Re: JW Broadcasting, Inc.
WCFO(AM), East Point, Georgia
Facility Identification Number: 15521
File Number: BP-20090313ACC

This letter refers to the above-captioned application for a minor modification of AM broadcast station WCFO.

LAMBERT EQUAL AREA MAP

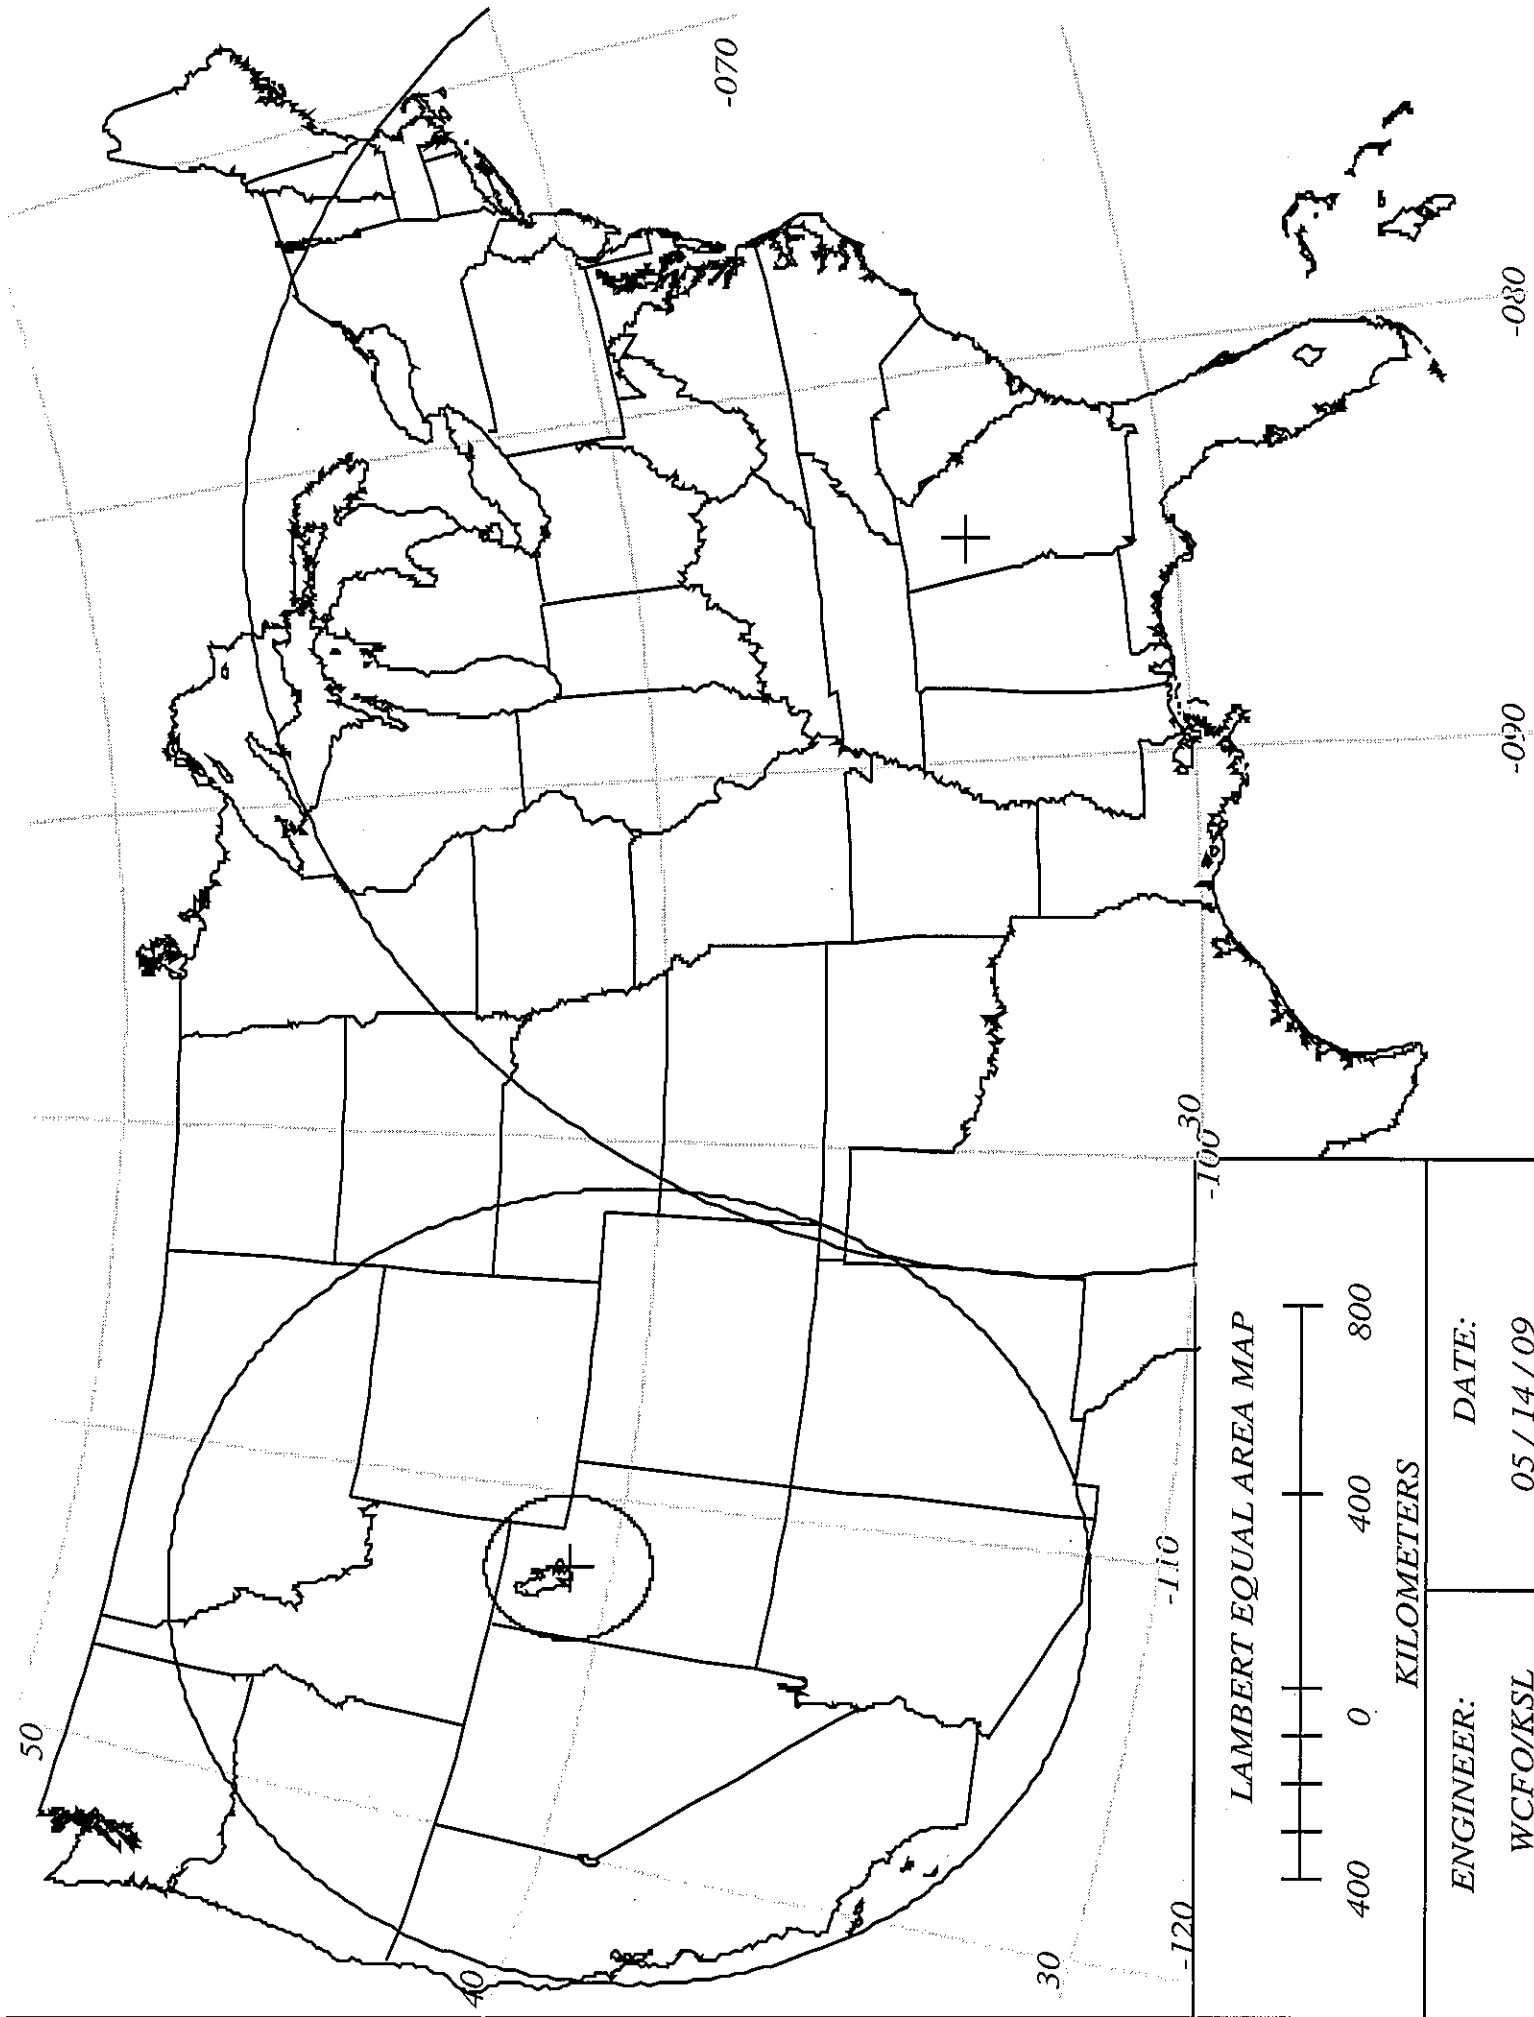
A preliminary engineering review of the application reveals that the proposed nighttime 0.025 mV/m-10% skywave contour overlaps the 0.5 mV/m-50% skywave contour of co-channel Class A station KSL(AM), Salt Lake City, Utah, in violation of 47 CFR Section 73.182 (See attached exhibit). In addition, the proposed nighttime operation would increase the existing 25% RSS limit of co-channel Class B station WEWC(AM), Callahan, Florida, in contravention of Section 73.182 of the Commission's Rules. Specifically, the existing RSS limit for WEWC is 12.12 mV/m, and the proposal will increase the limit to 12.59 mV/m.¹

Accordingly, the application BO-20090313ACC IS HEREBY DISMISSED. This action is taken pursuant to Section 0.283 of the Commission's rules.
